#### PLANNING AND ZONING COMMISSION AGENDA-REGULAR MEETING

Monday, April 9, 2018 Ketchum City Hall 480 East Avenue North, Ketchum, ID 83340

### STAFF REPORT KETCHUM PLANNING AND ZONING COMMISSION REGULAR MEETING APRIL 9, 2018

### STAFF REPORT KETCHUM PLANNING AND ZONING COMMISSION REGULAR MEETING OF APRIL 9<sup>th</sup>, 2018

A-2.1

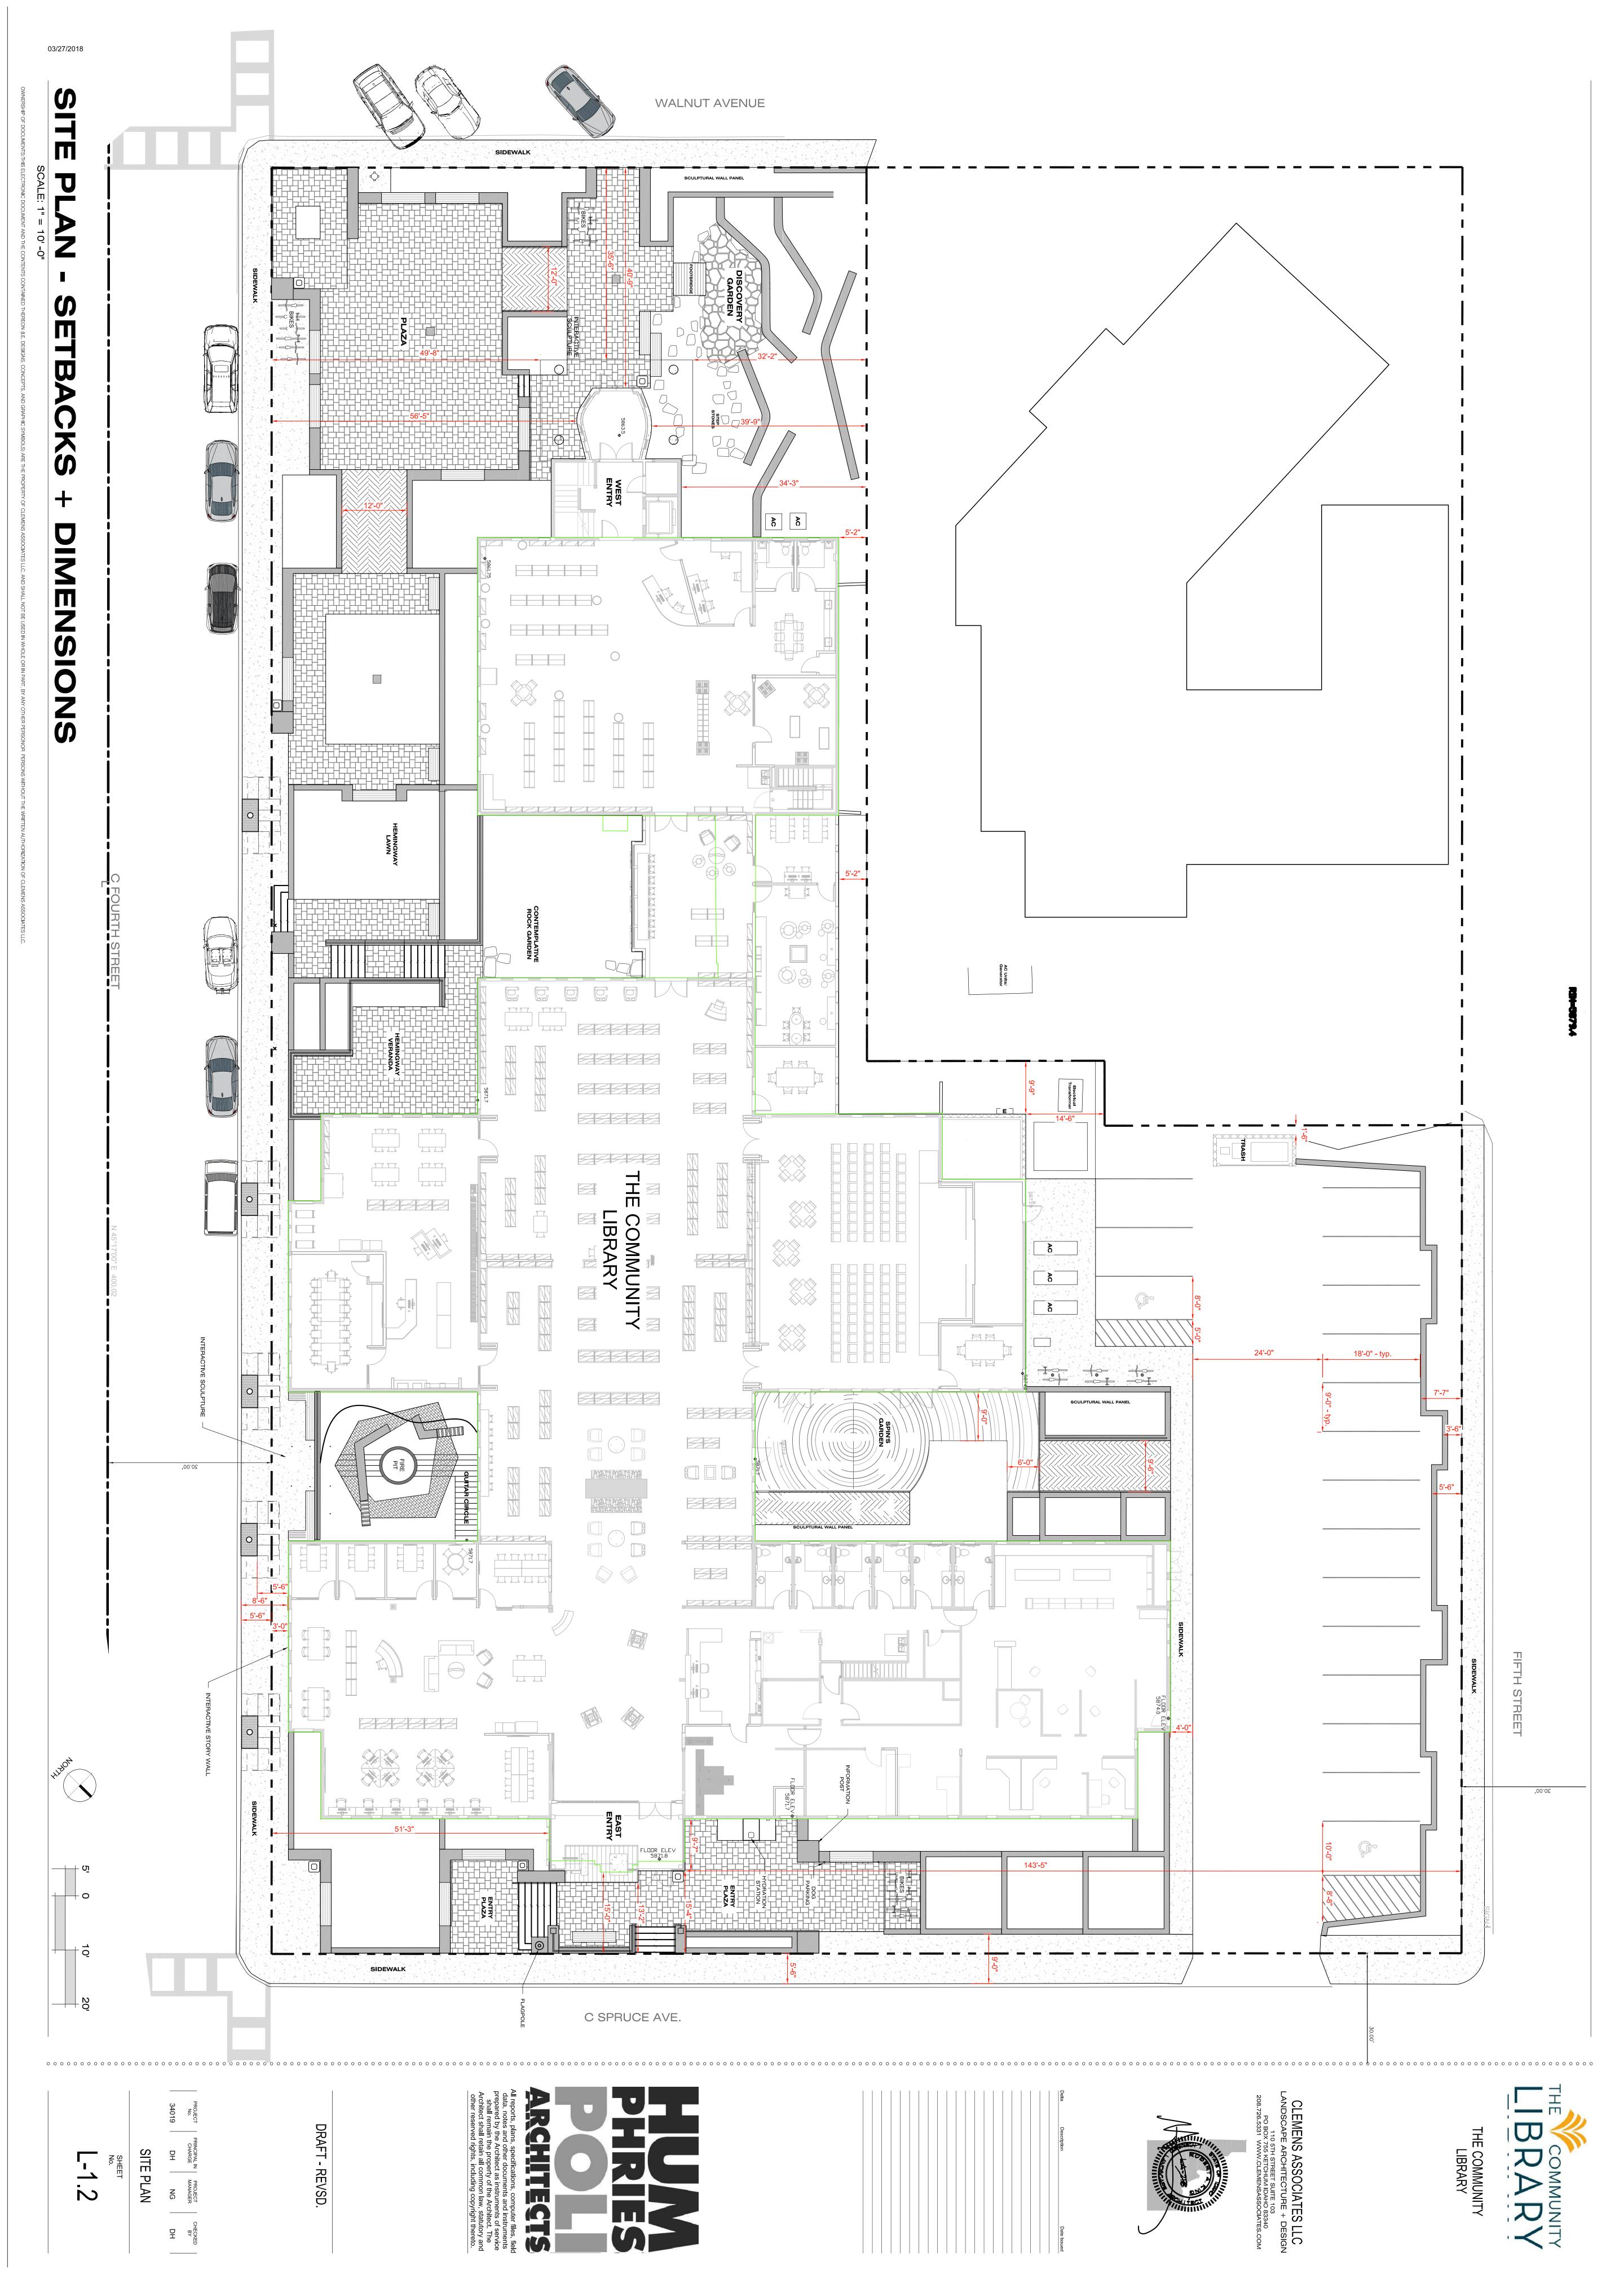
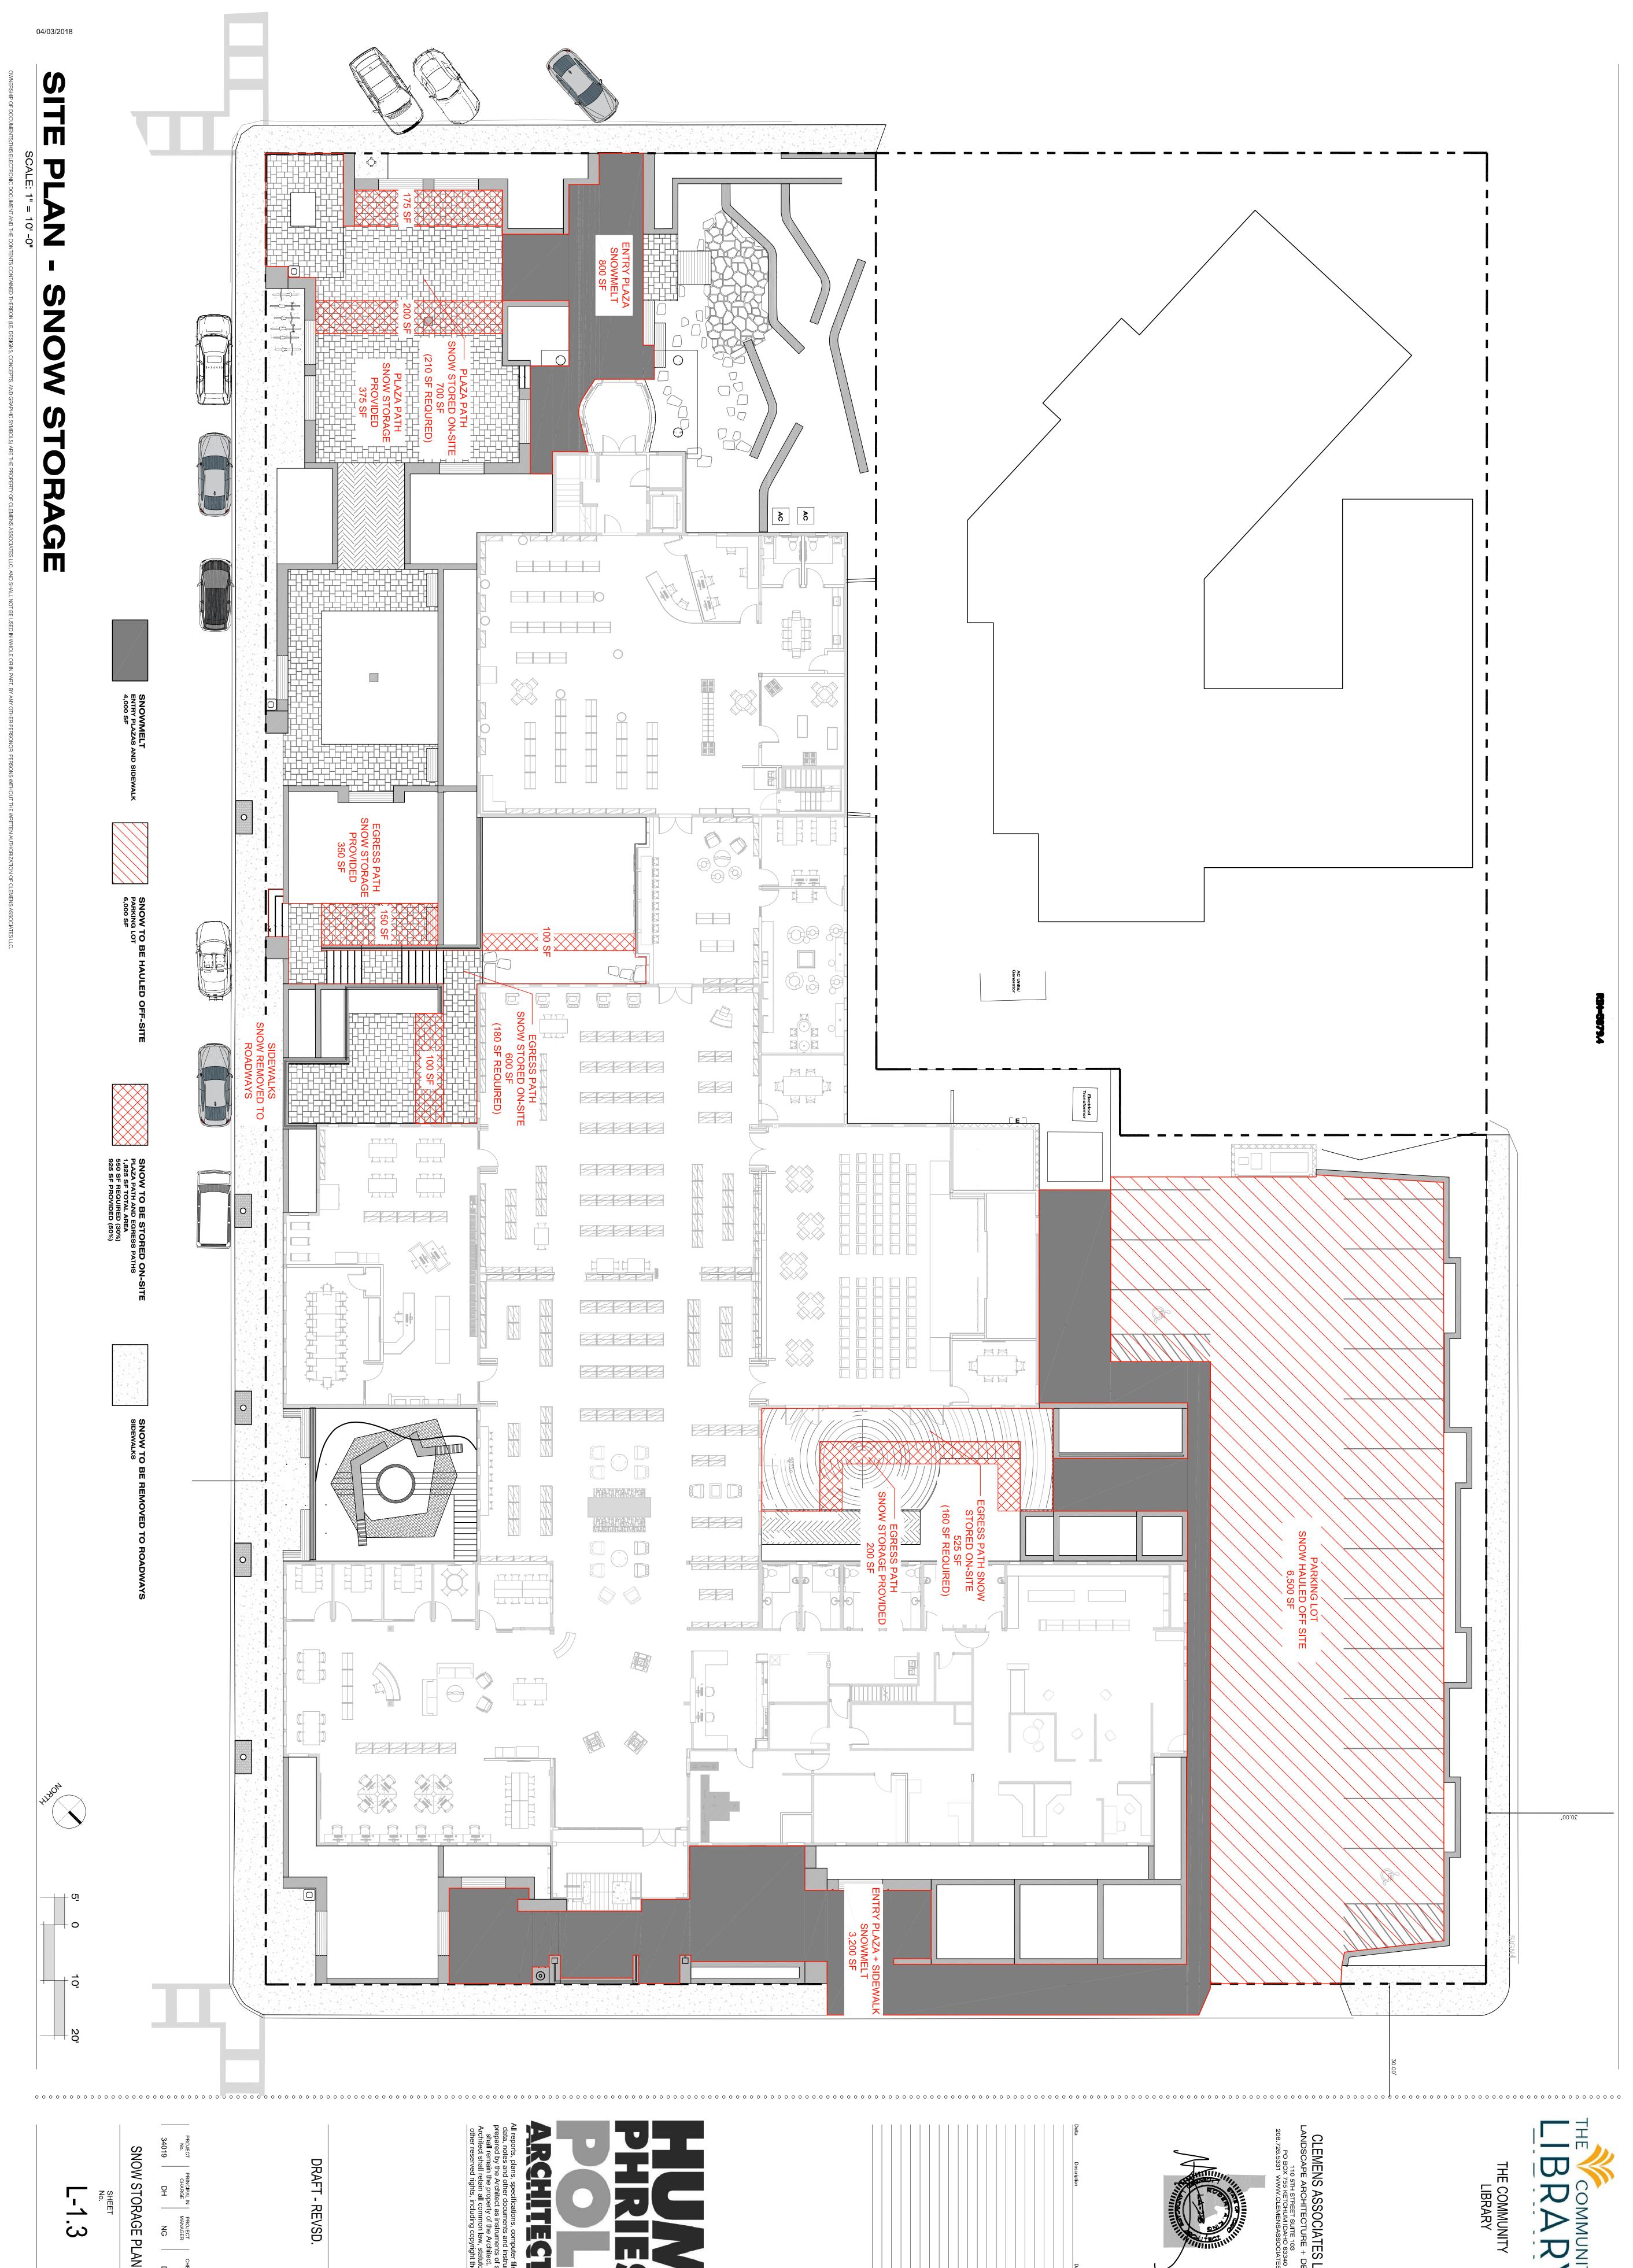
Stuff comments	oriented towards Walnut Avenue.
	<del>                                     </del>	17.96.060(F)(7)	Garbage storage areas and satellite receivers shall be screened from public view and
$\boxtimes$		17.50.000(1)(7)	located off alleys.
		Staff Comments	Sheet A2.1 of the submittal indicates that the dumpster will be screened with a metal
			and wood enclosure.
